## ADDENDUM NO. 2

RE: Site Improvements and Renovations to Davis Hall  
Bridge Valley Community and Technical College  
Montgomery, West Virginia 25136  
Architect's Job No. 18046

**SITE LIGHTING PLAN**  
1/16" = 1'-0"

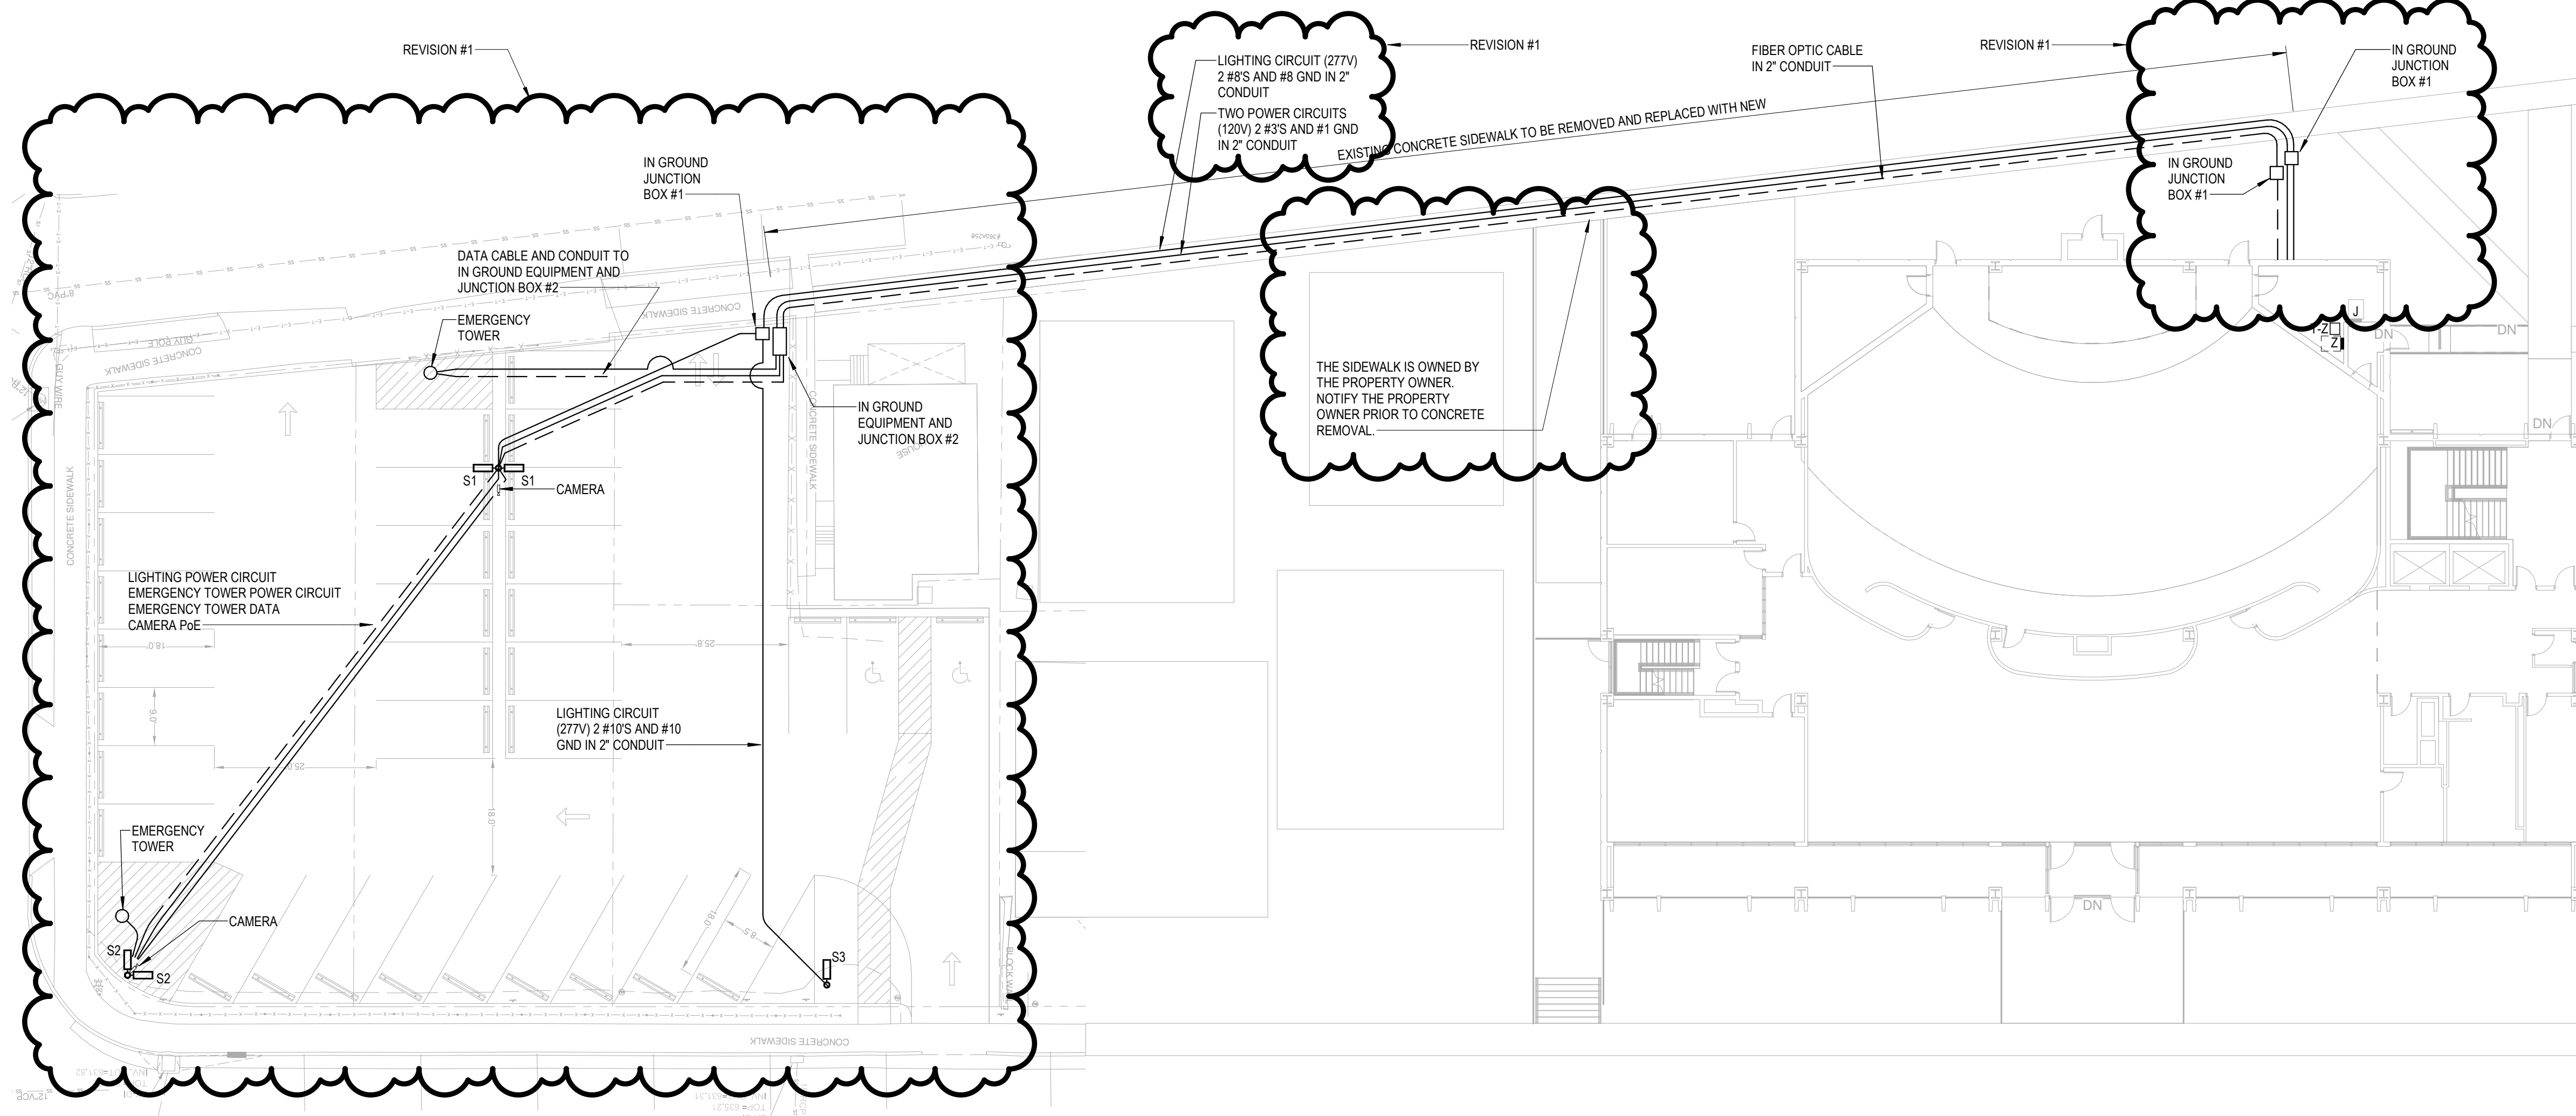
**REVISION #1: REVISED  
GENERAL NOTES**

- ALL EXTERIOR UNDERGROUND CONDUITS SHALL BE 1" PVC MINIMUM SIZE INGROUND POLYMER CONCRETE PULLBOXES AS REQUIRED PER NEC FOR CONDUIT ENTRY AND EXITING.
- SEE SPECIFICATIONS FOR INDUSTRIAL POE SWITCH. INSTALL POE SWITCH IN A NEMA 3R BOX WITHIN THE INGROUND JUNCTION BOX #2. SEE SPECIFICATIONS.
- SEE SPECIFICATIONS FOR CAMERA. THE CAMERA SHALL BE INCORPORATED INTO THE EXISTING SURVEILLANCE SYSTEM. MOUNT THE CAMERA TO THE SITE LIGHTING POLES. COORDINATE THE WORK WITH OTHER TRADES. SEE SPECIFICATIONS.
- SEE SPECIFICATIONS FOR EMERGENCY TOWER.

**3 IN-GROUND EQUIPMENT AND JUNCTION BOX #2 DETAIL**  
NO SCALE

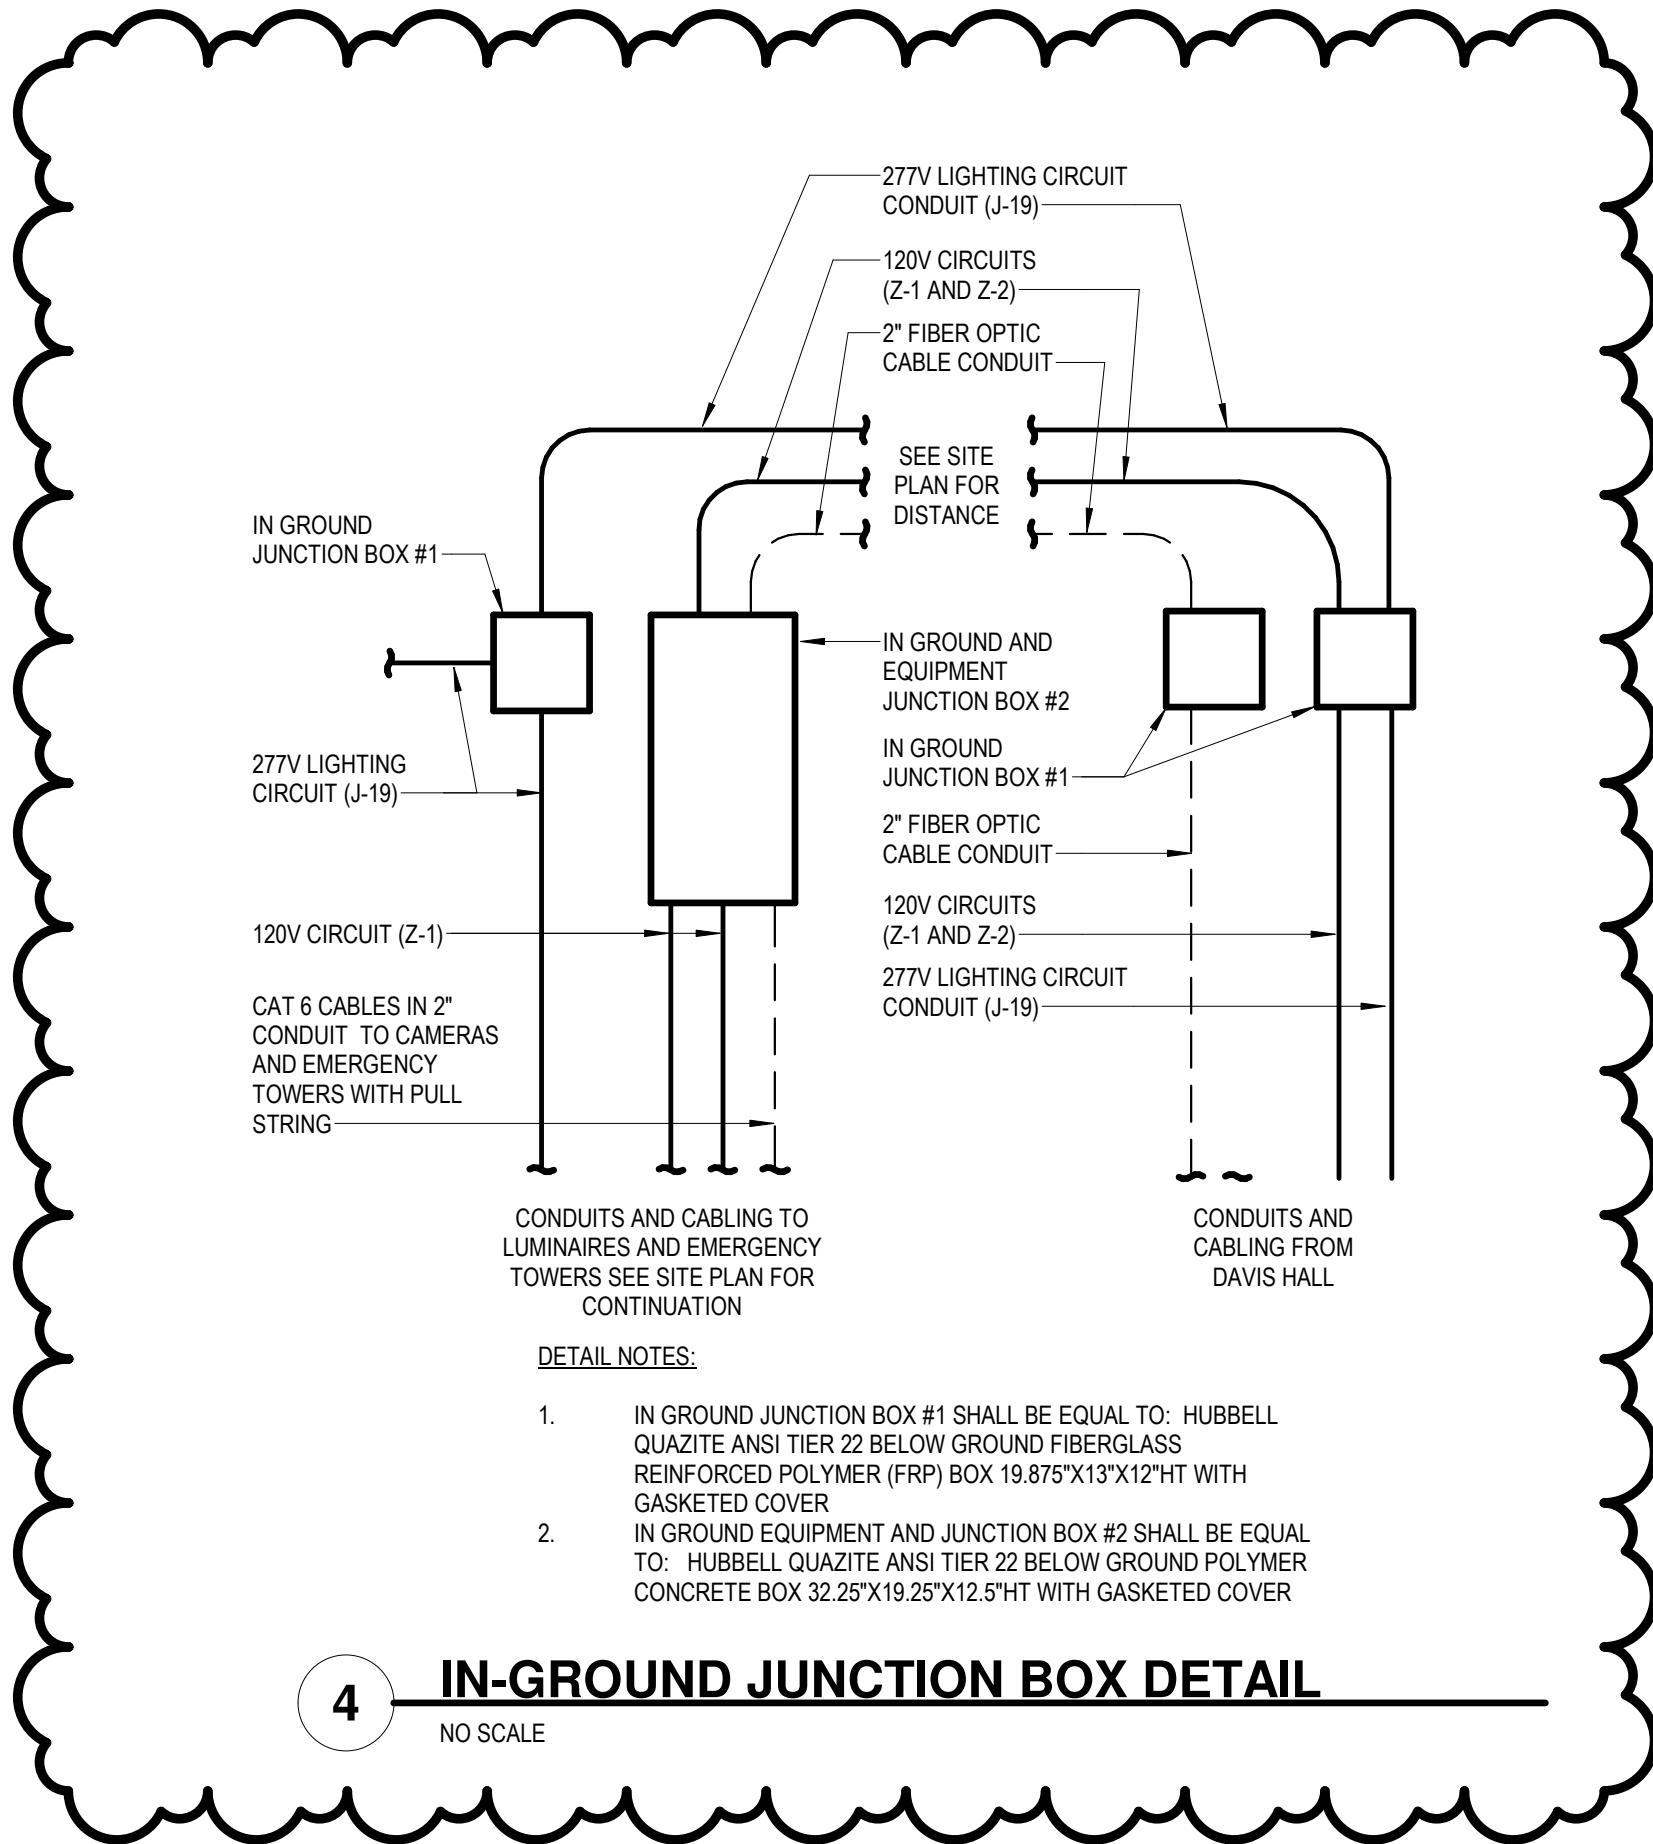
**REVISION #1: ADDED DETAIL**

**1 POLE BASE DETAIL PAVED PARKING**  
NO SCALE

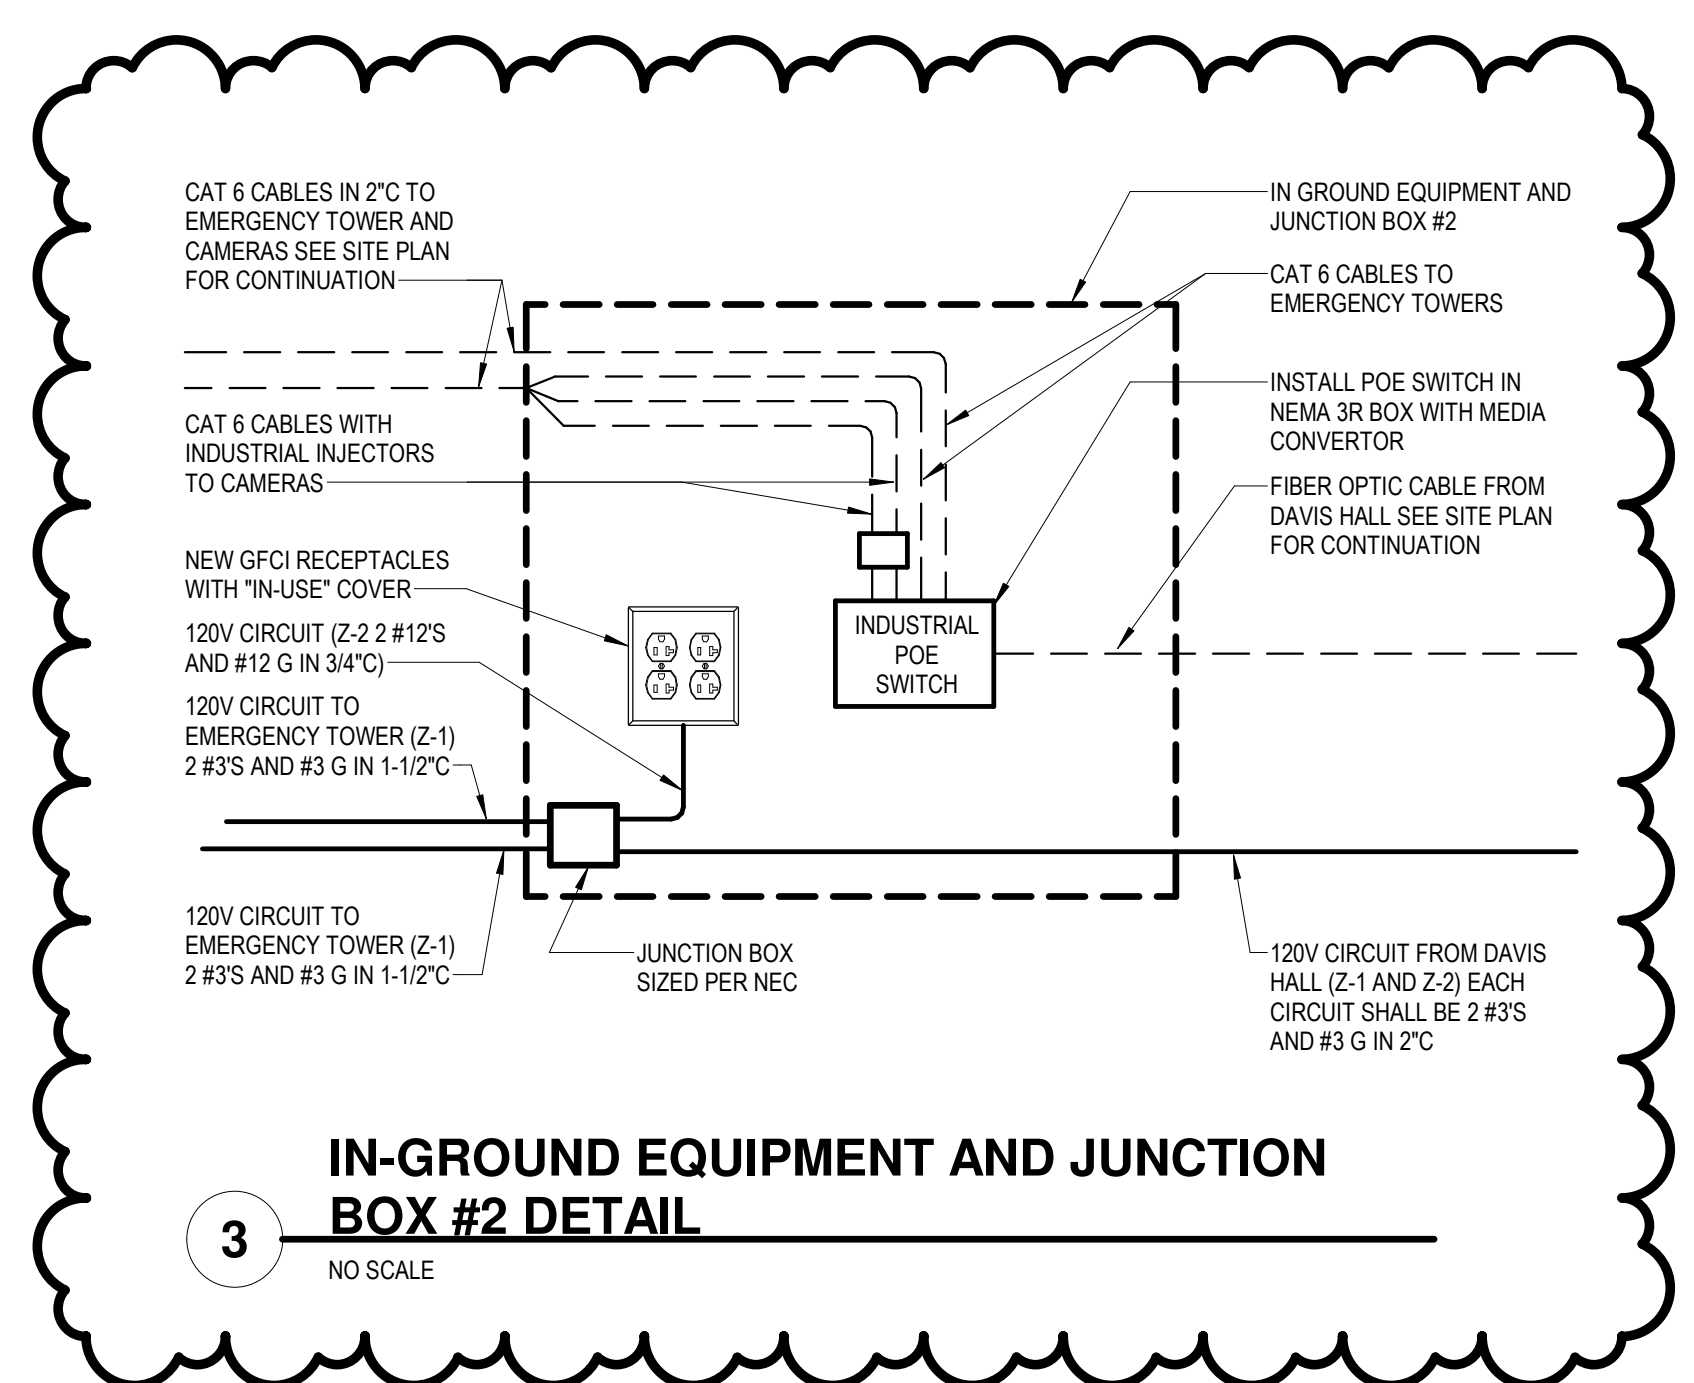
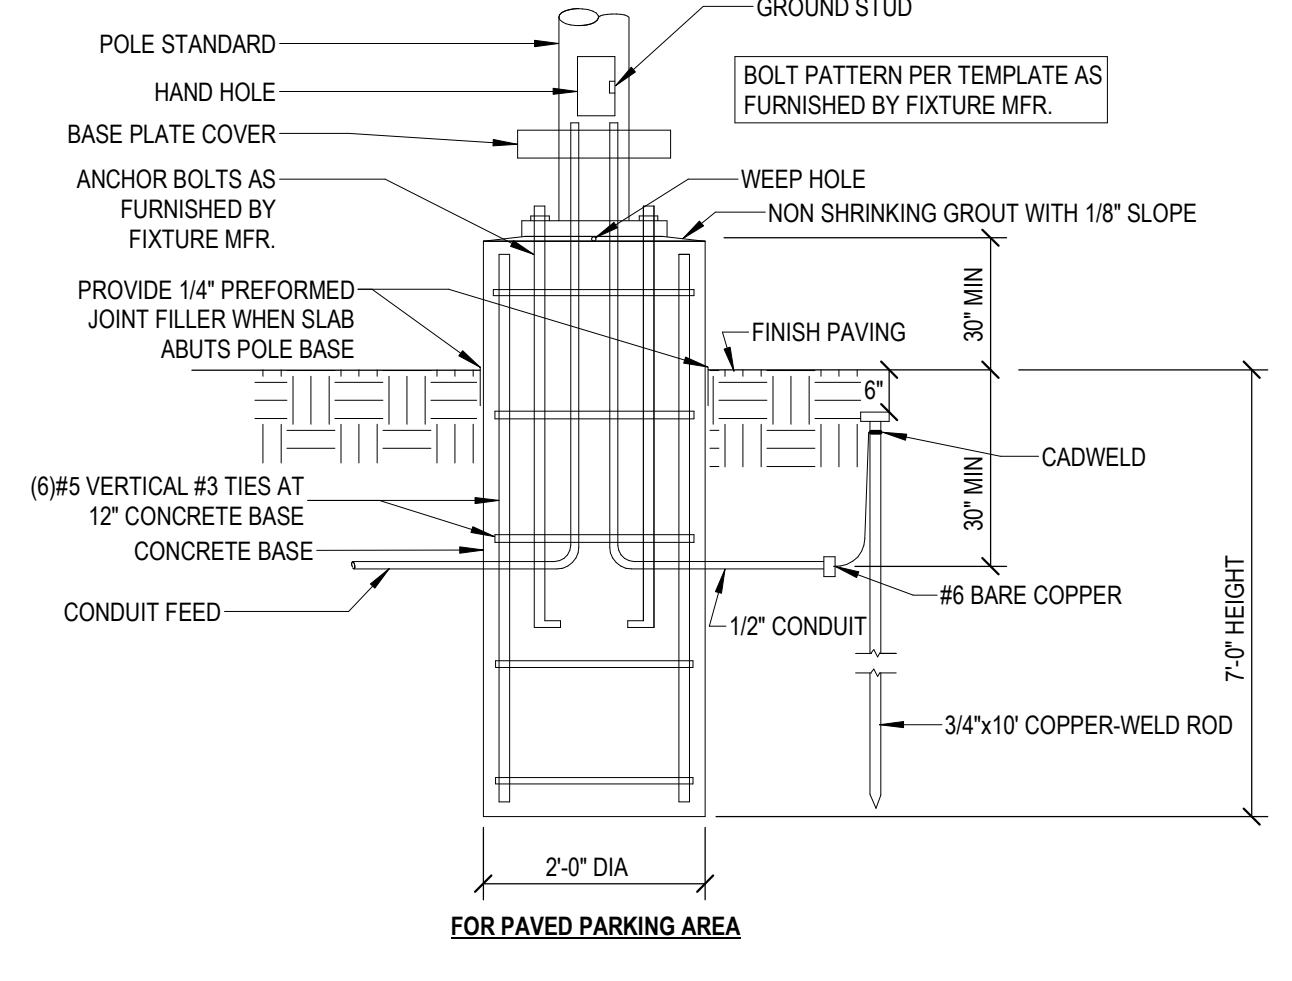
**REVISION #1: REVISED DETAIL**
